MONITORING YEAR 1 ANNUAL REPORT FINAL

Liberty Rock Mitigation Site

RE: DMS Comments on the MY1 Report
Liberty Rock, Project ID #100135, DMS Contract 7877-01

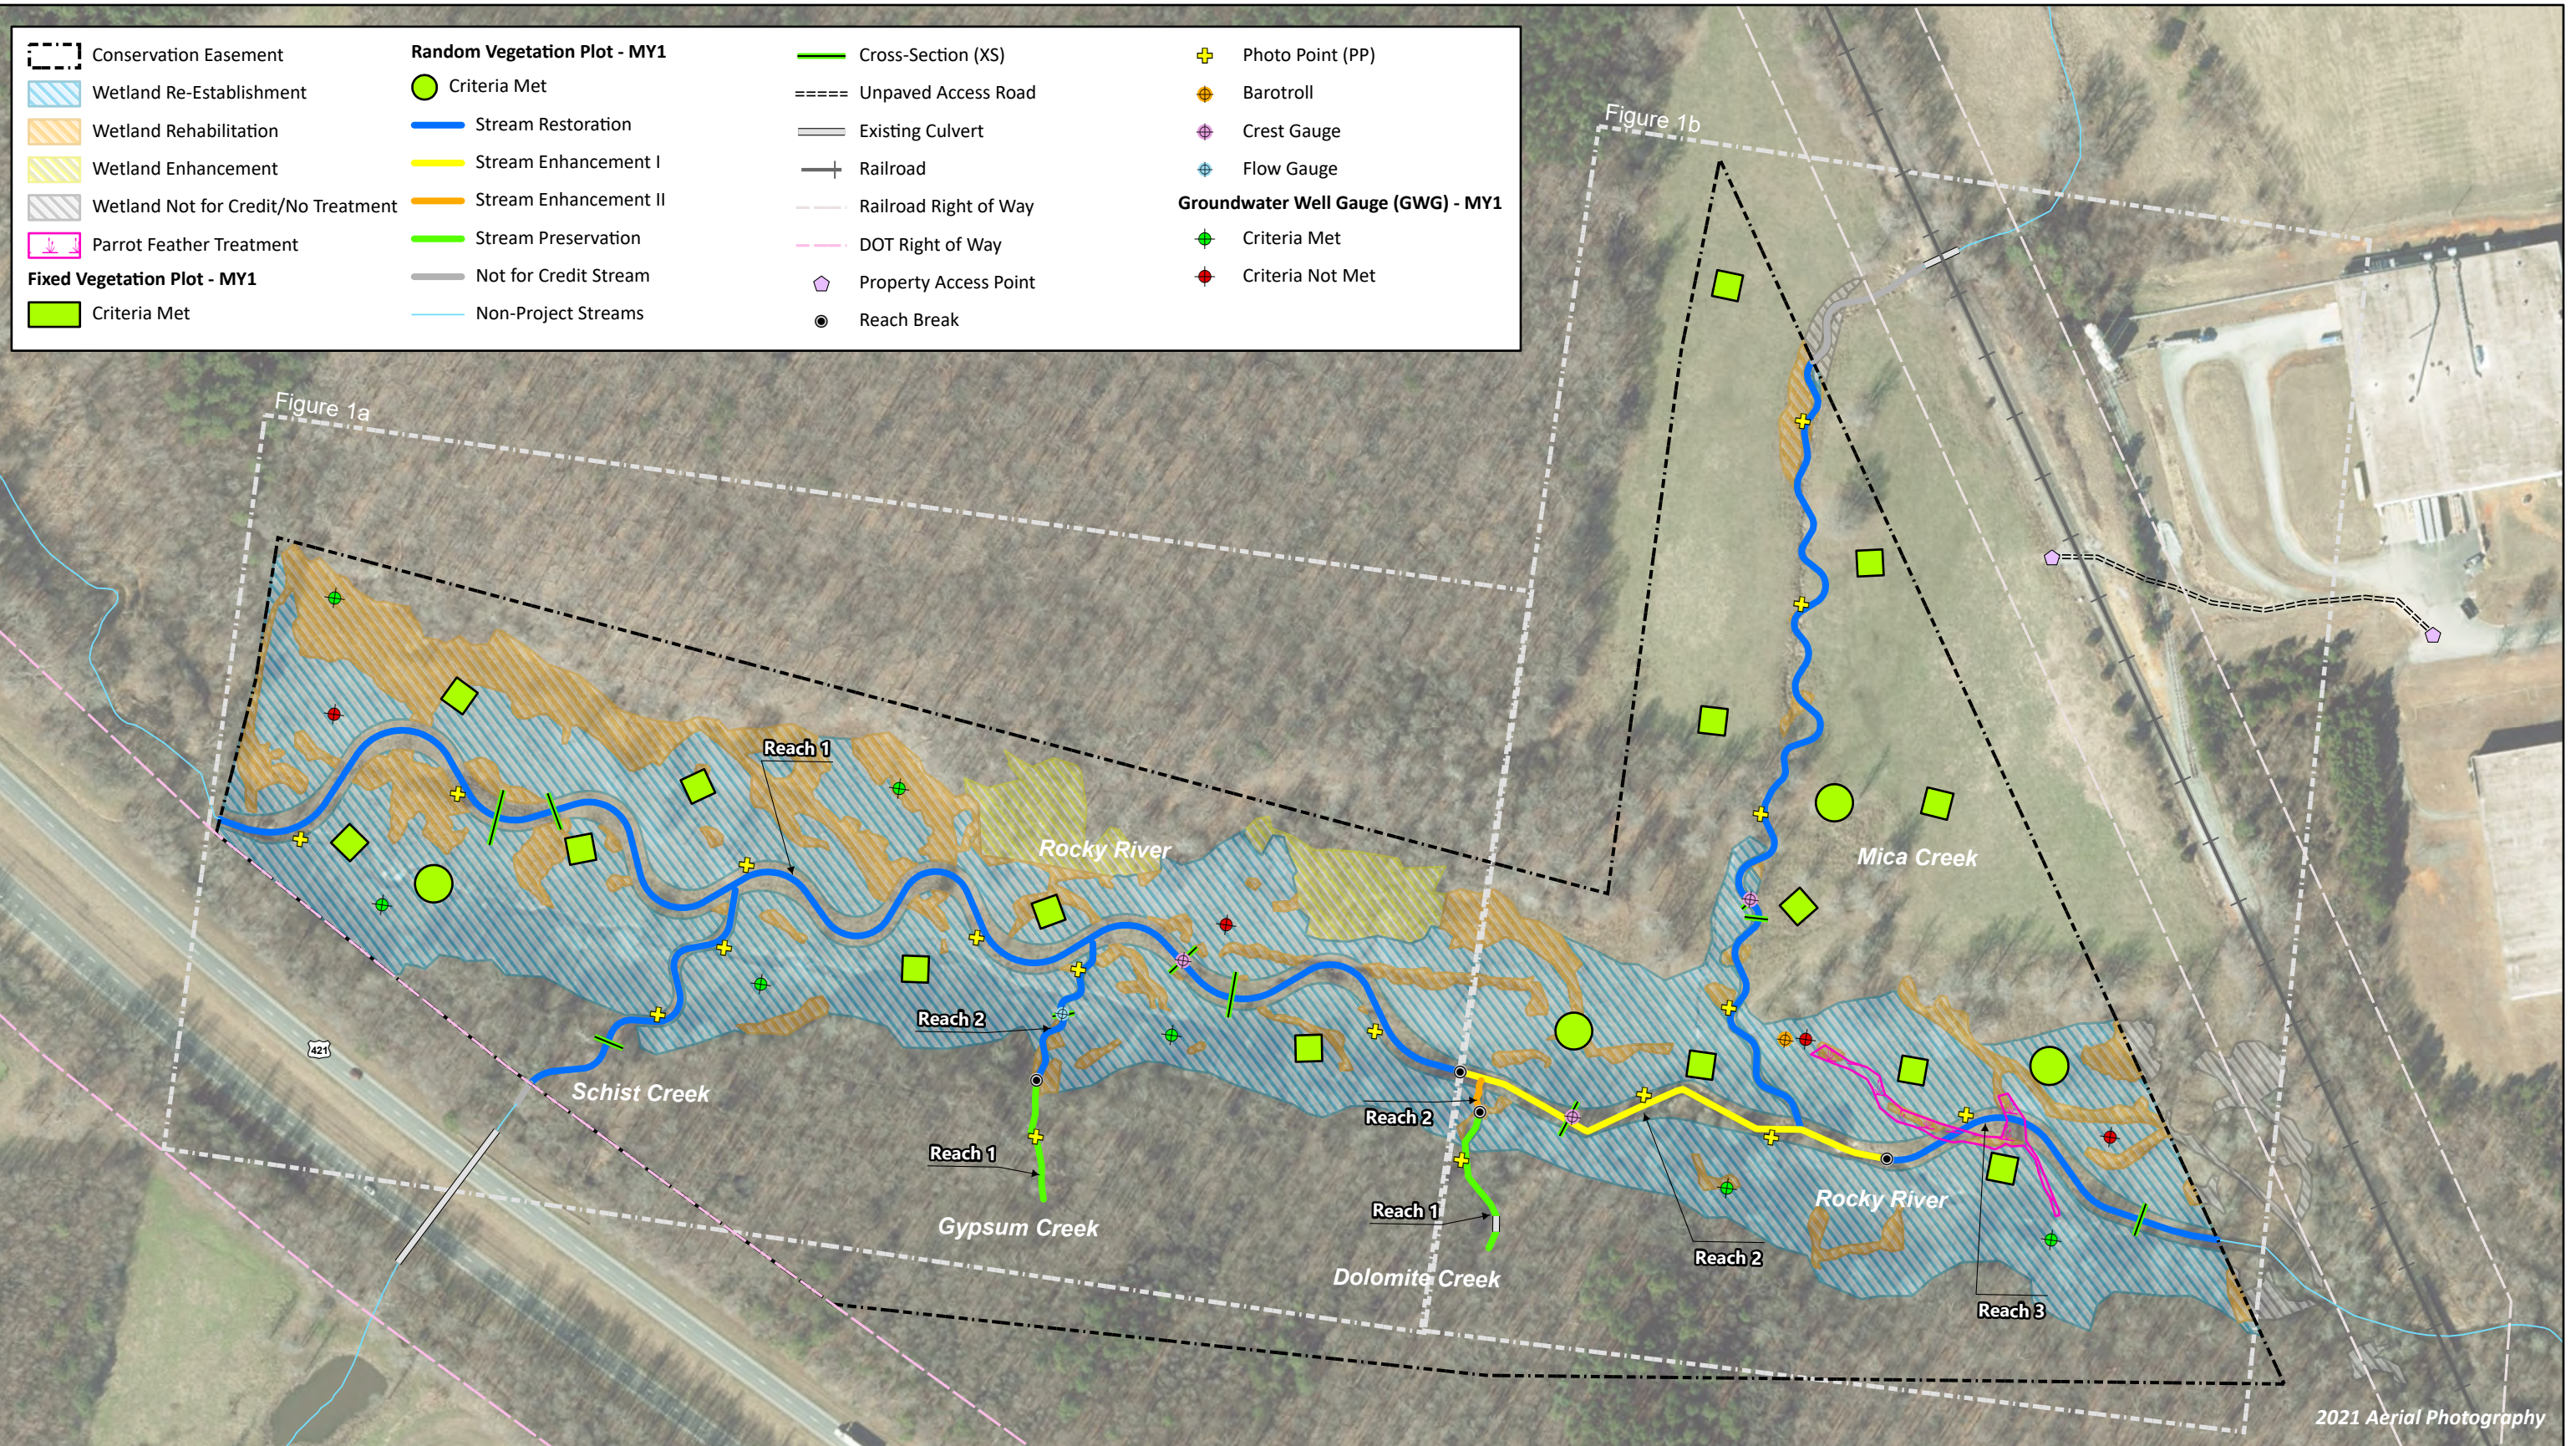
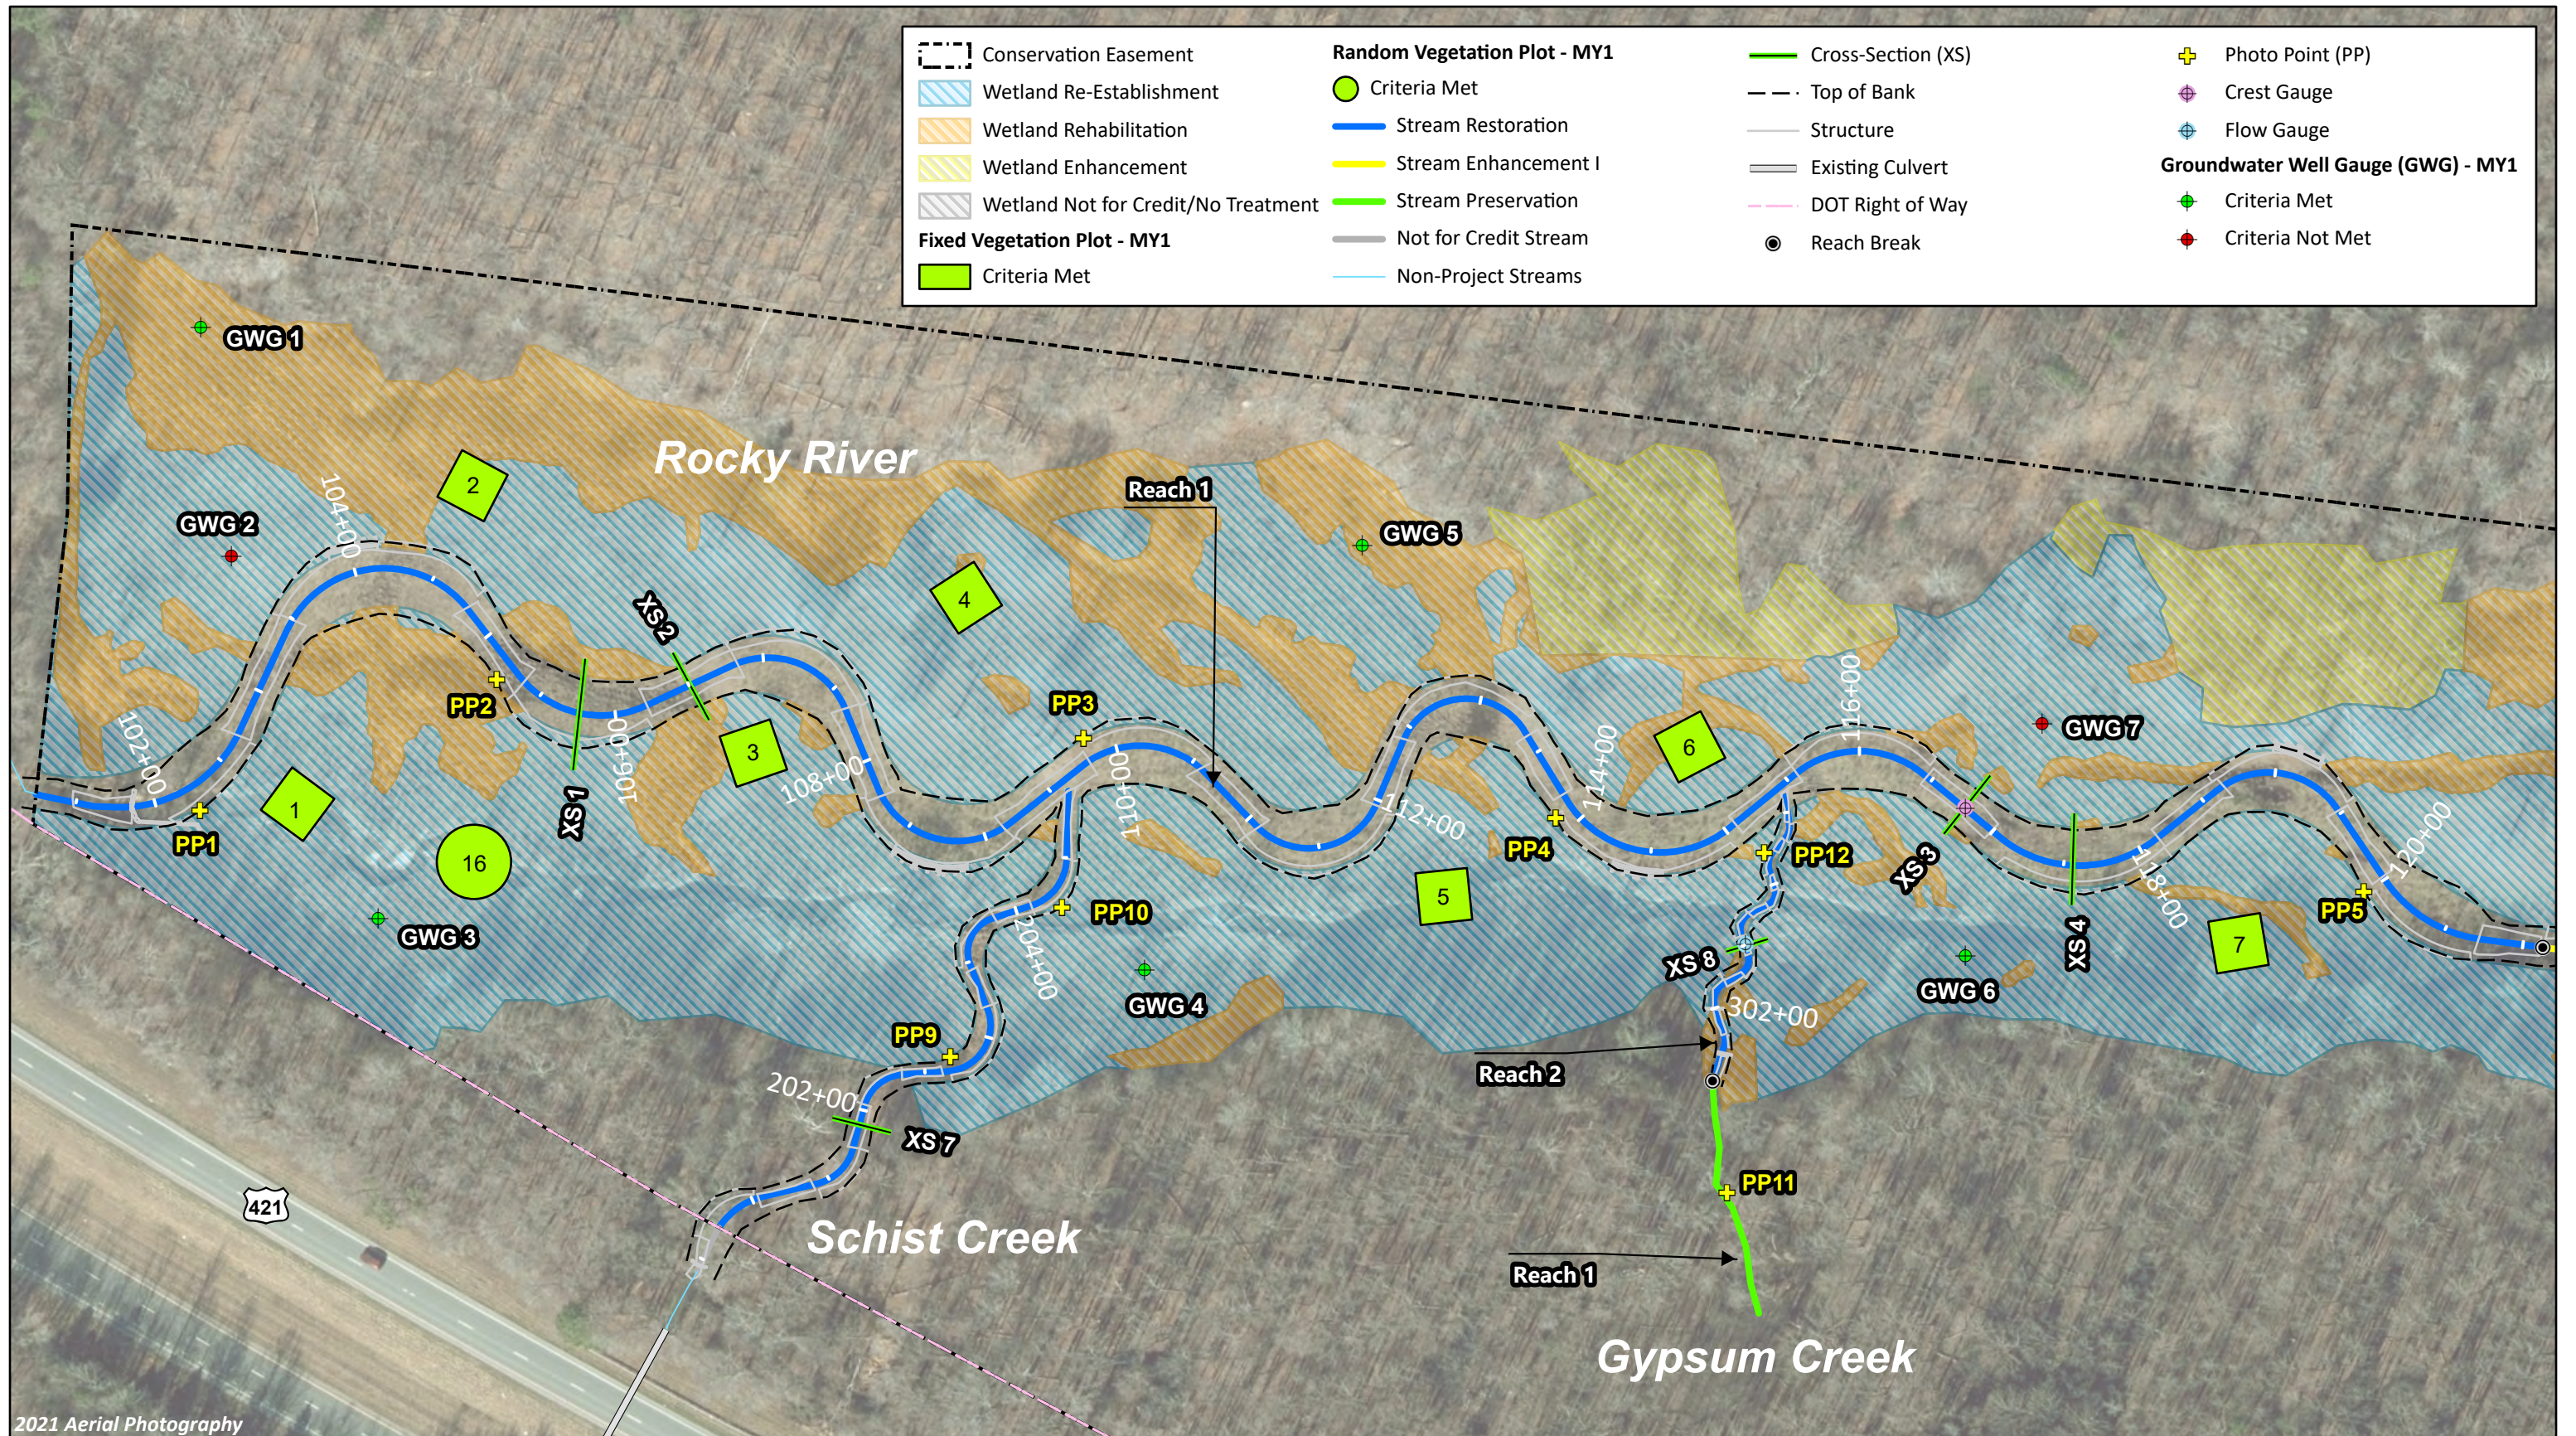
Response: The growing season was approved in the Mitigation Plan and is March 1st – November 21th each year. Section 2.6 has been updated.
3. Figure 1 & 1b – Please show your best estimation of the vehicle encroachment location.

Response: Figure 1b has been updated to include approximate location of the vehicle encroachment extent.
4. Can the multiflora rose and privet treatment indicated in Section 2.2 be shown on the CCPV, or were these scattered occurrences?
